I-66 and US 27 Interchange

Somerset, Kentucky

VALUE ENGINEERING STUDY
for the
Kentucky Transportation Cabinet

Final Report

SKETCH OF RECOMMENDED DESIGN

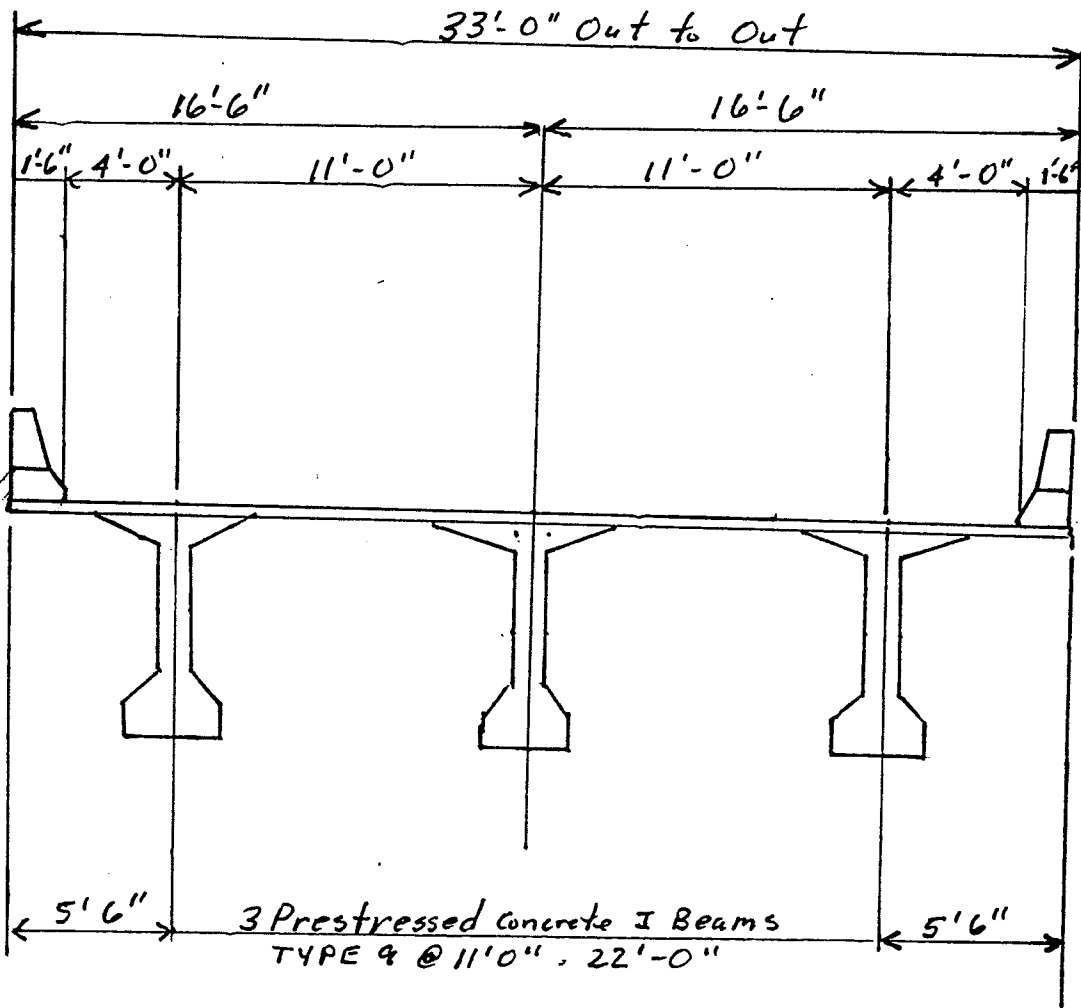
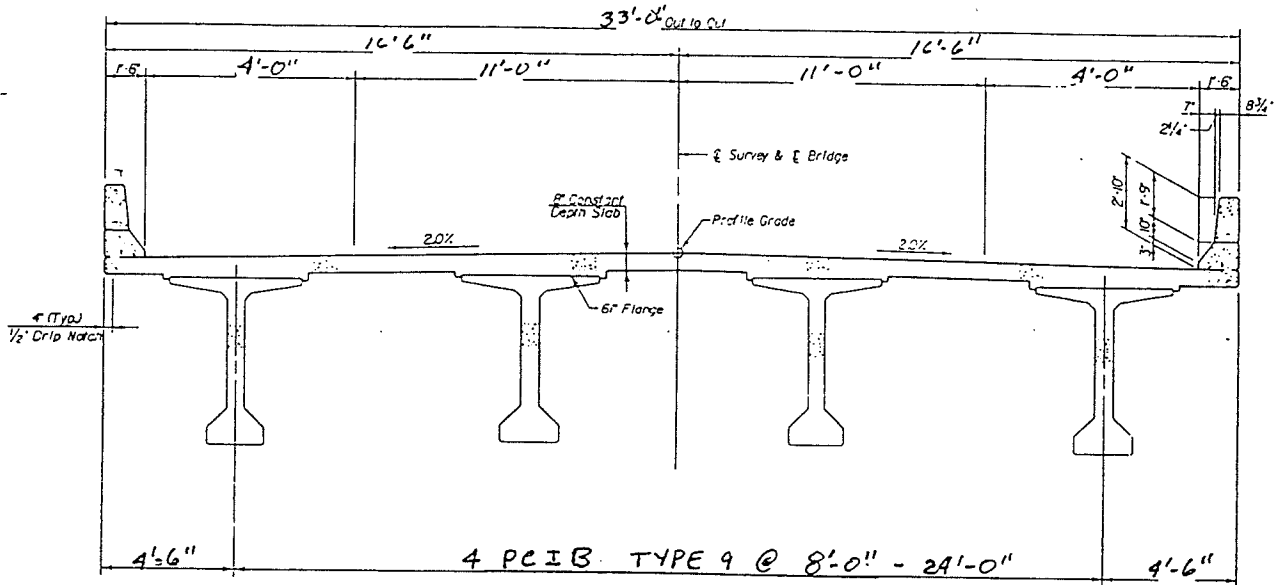
DESCRIPTIVE TITLE OF RECOMMENDATION:
Reduce Width of Clifty Road Bridges.

Original bridge is designed with two 12 foot lanes and 8 foot shoulders to match new Clifty Road typical.

Build bridge with two 11 foot lanes and 4 foot shoulders.

The current roads this bridge is providing access to (Clifty Road, Wilson Road, Norwood Road) are currently 16 feet to 17 feet with no shoulders. Even with future development the reduced bridge width will accommodate projected traffic volumes. Studies presented at Contech Sensitive Design Training indicate no added benefits between 11 foot and 12 foot lanes for safety or capacity.

(Alternate if three Line Type 9 beams are not adequate)

GEOMETRIC LAYOUT SHEET
 SOMERSET NORTHERN BYPASS
 U.S. 27 INTERCHANGE

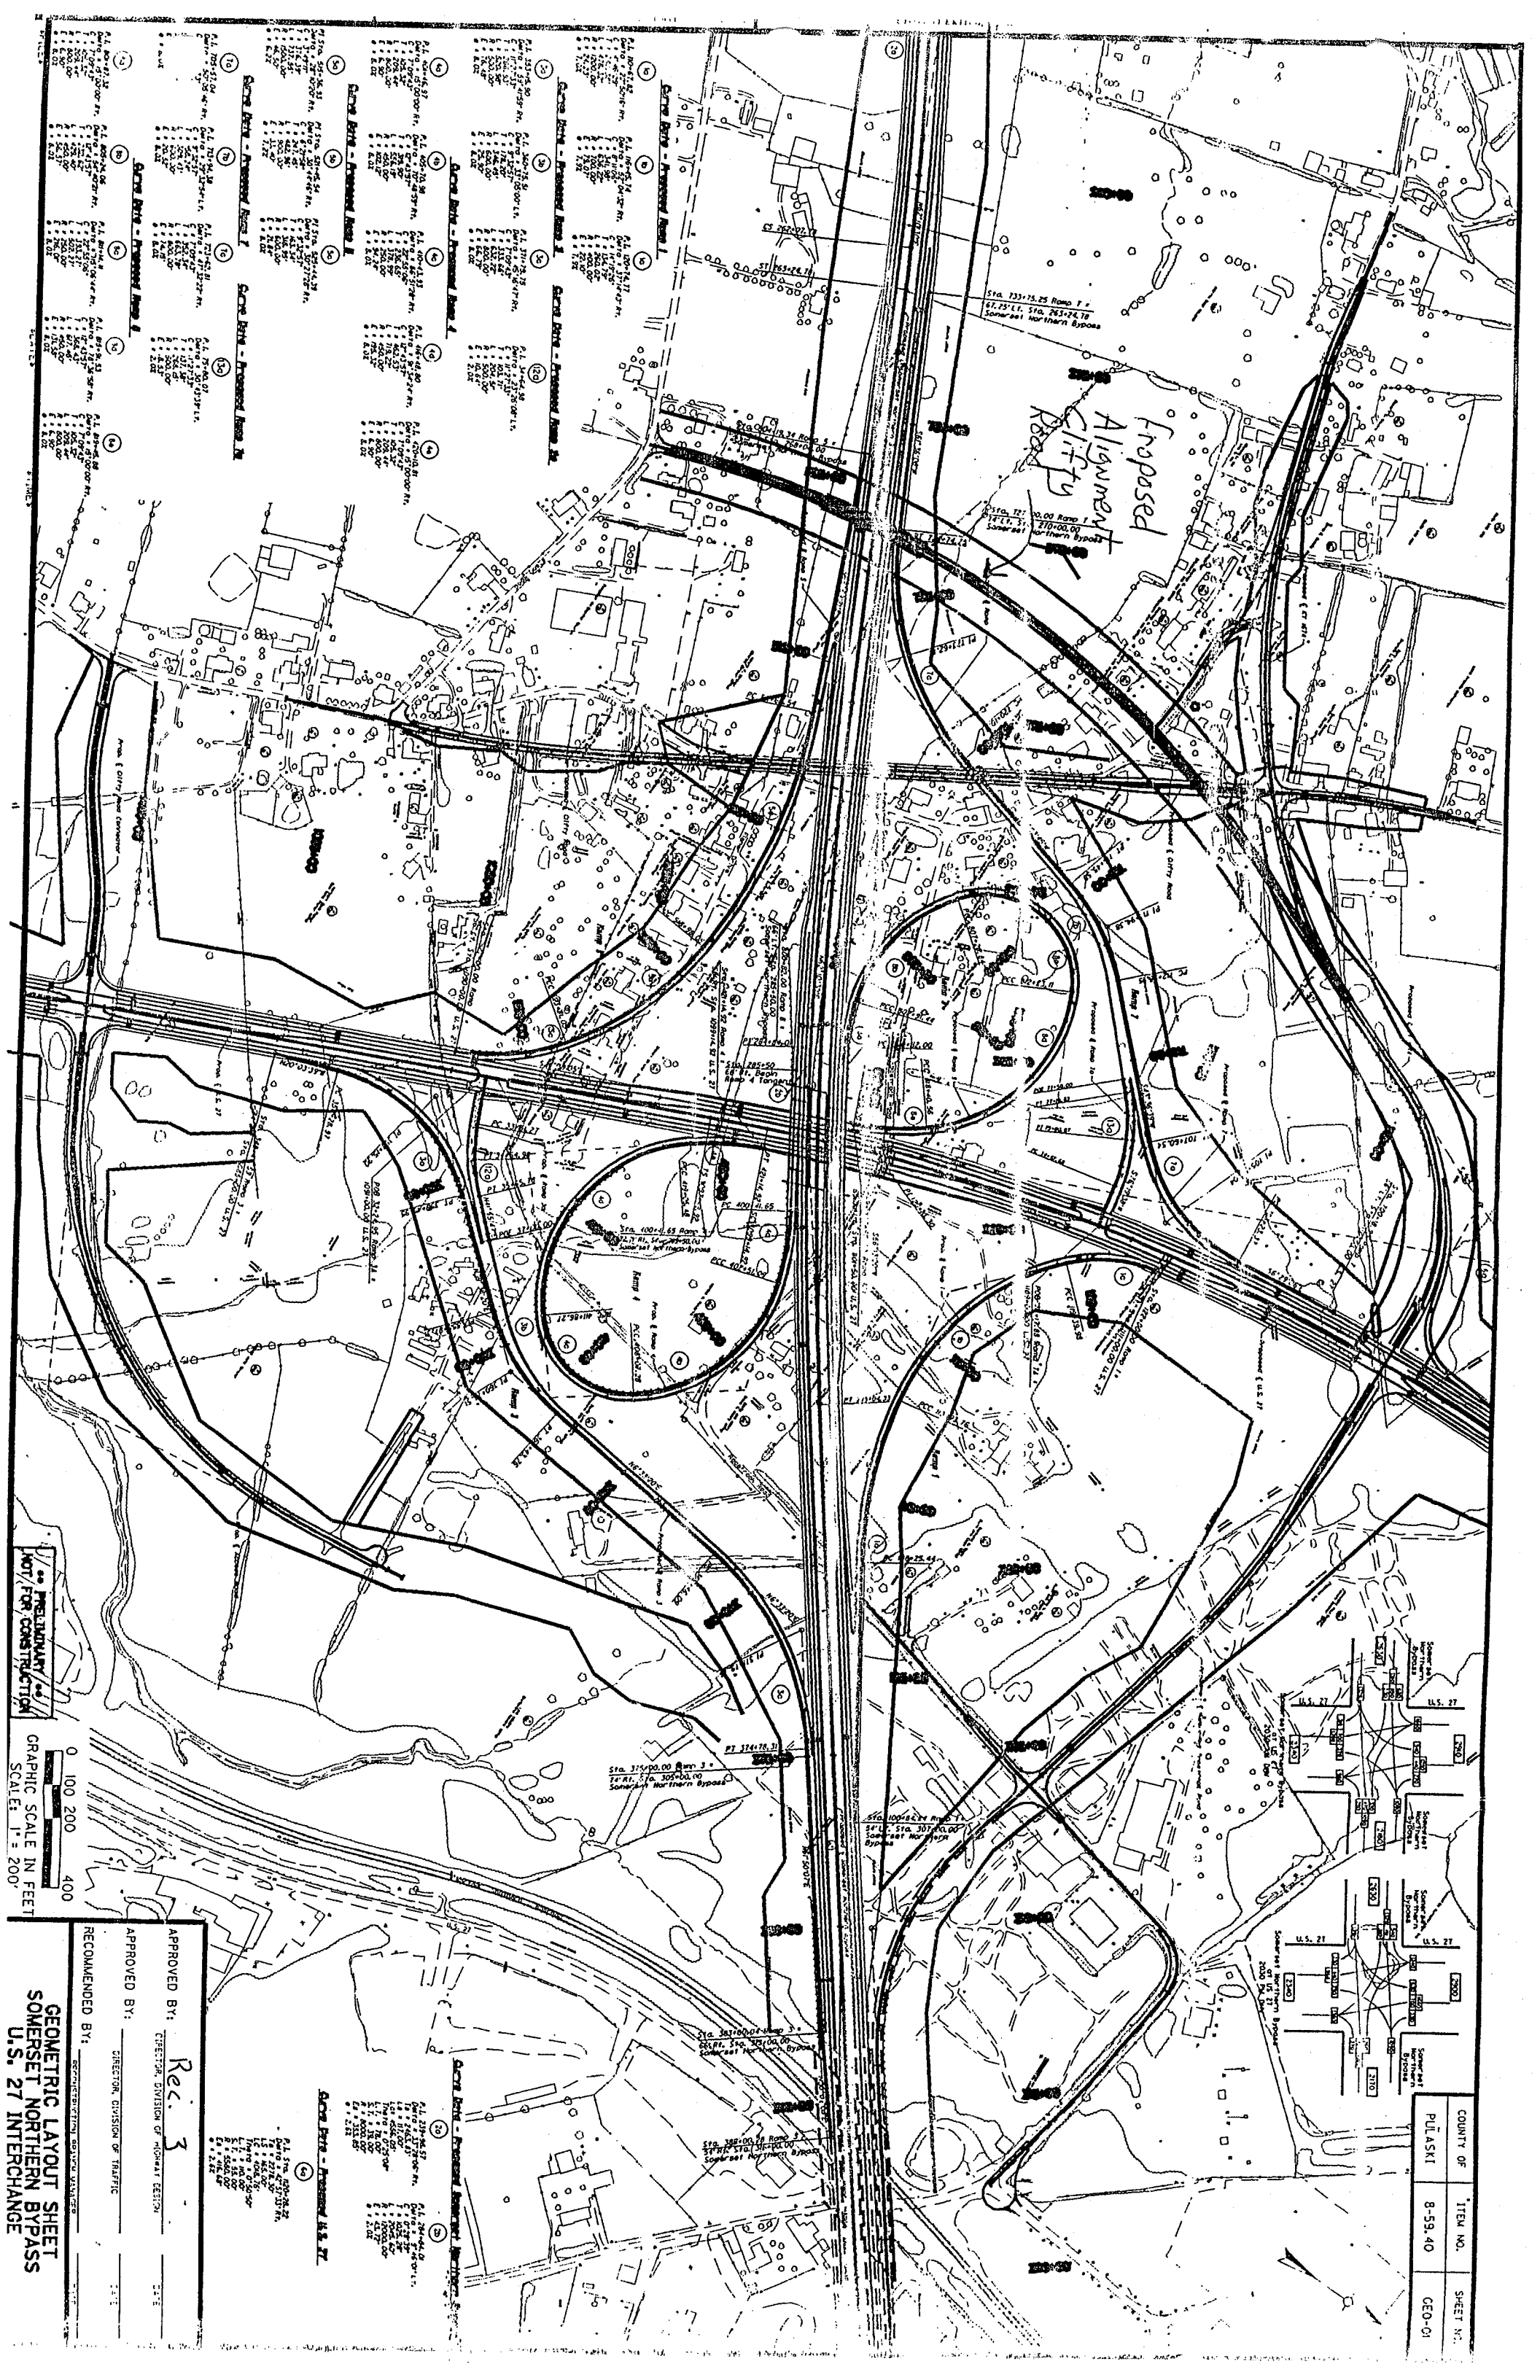
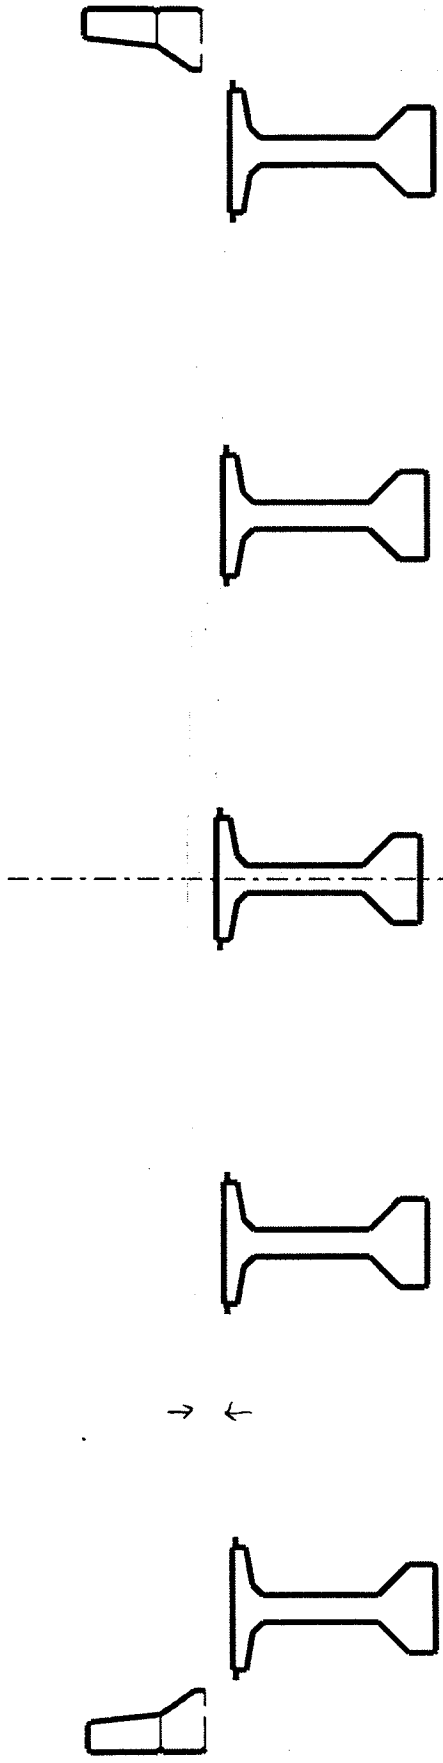
Realign Clifty Roads

Reconstruct Clifty Road utilizing long bridge over I-66 and Ramp 7 in order to maintain traffic on Clifty Road and keep in approximately the same corridor.

Move Clifty Road Corridor to the west side of the church into "shorter" structure and construct less overall new roadway.

The “function of maintaining local access from the north to south for Clifty Road is met, with the corridor remaining in the area of the church while eliminating major construction and disruption at the church. Cost savings are significant.

APPROVED BY: **Figure 1**
 DIRECTOR, DIVISION OF HIGHWAY DESIGN
 APPROVED BY: _____
 DIRECTOR, DIVISION OF TRAFFIC
 RECOMMENDED BY: _____
GEOMETRIC LAYOUT PLAN
SOMERSET NORTHERN BYPASS
U.S. 27 INTERCHANGE

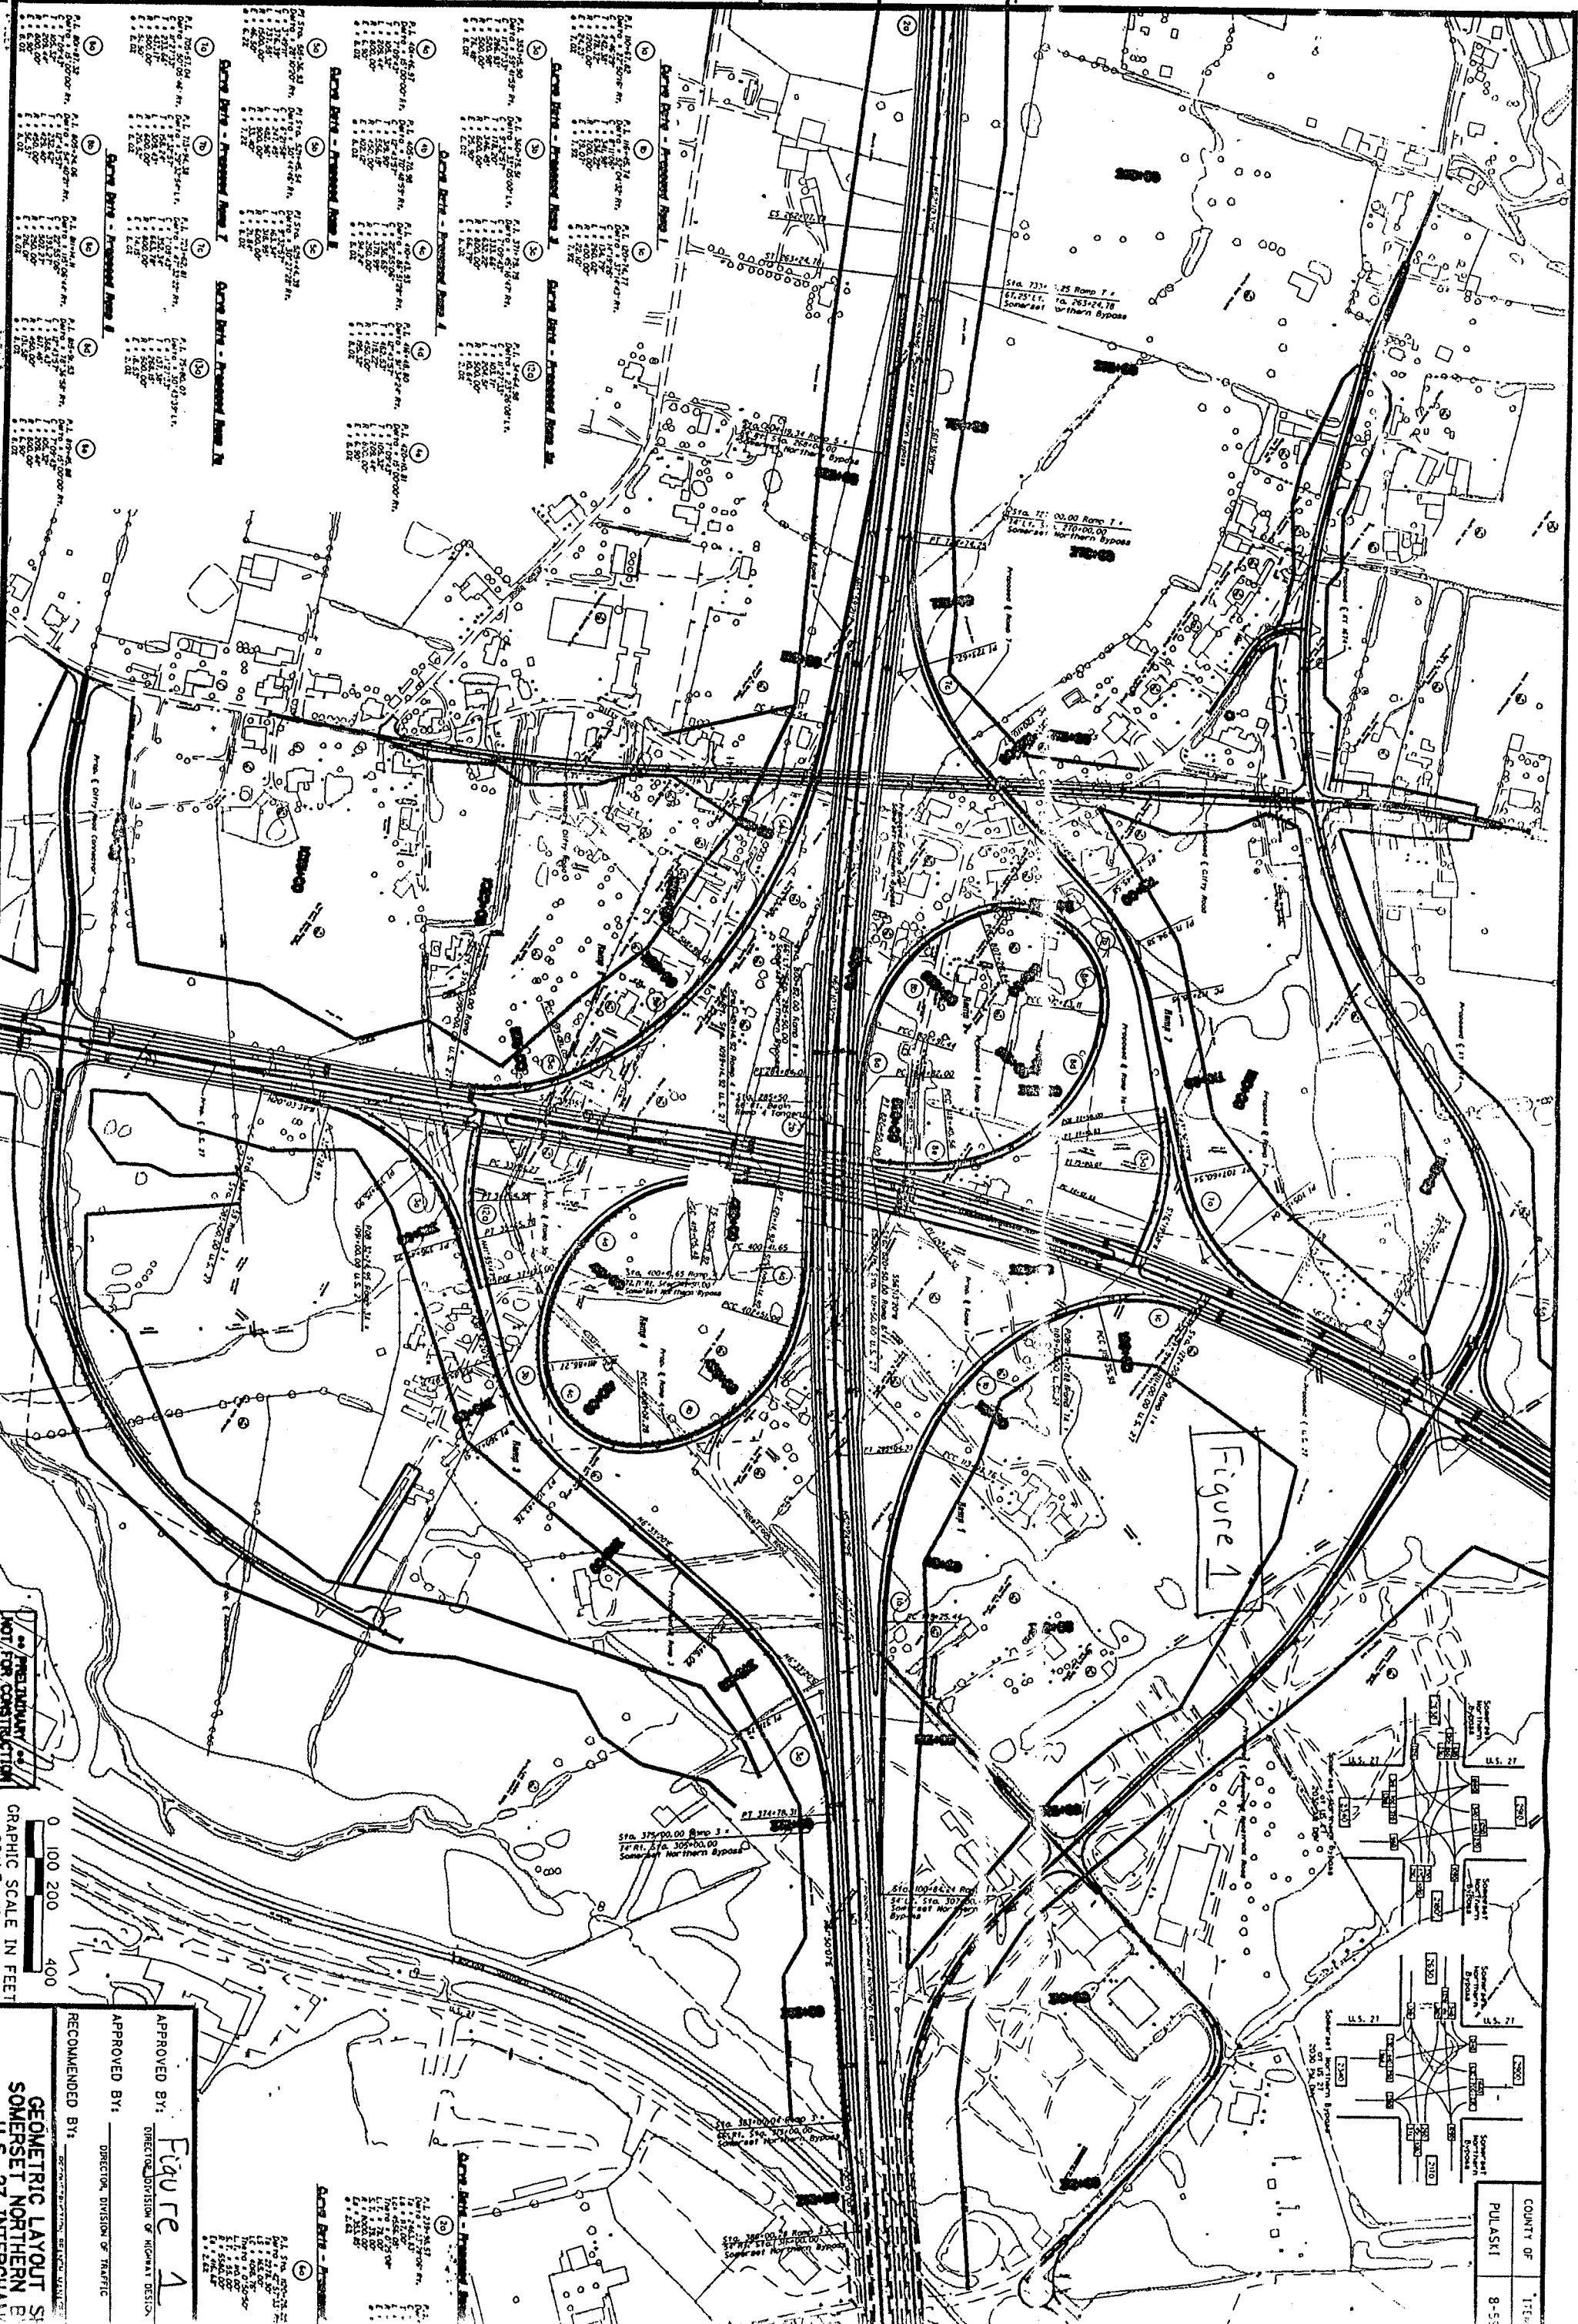
DESCRIPTIVE TITLE OF RECOMMENDATION:
Modify Interchange Loops

The interchange of I-66 and US 27 is designed as a four quadrant partial cloverleaf with loops in the north-west and south-east quadrants. The interchange scheme is designed to eliminate left turn movements on exit ramps by routing them 270 degrees through the loop.

Design the Interchange as a two quadrant diagonally opposite partial clover leaf with loops carrying all of the exiting traffic in the north-west and south-east quadrants. The loops will contain a right only lane and dual lefts for entry onto US 27.

The elimination of the ramps in the southwest and northeast quadrants will result in significant earthwork deductions while still providing adequate levels of service throughout the interchange. The bridge for Clifty Road will be able to be shortened, and less right of way will be required. These changes should result in significant changes.
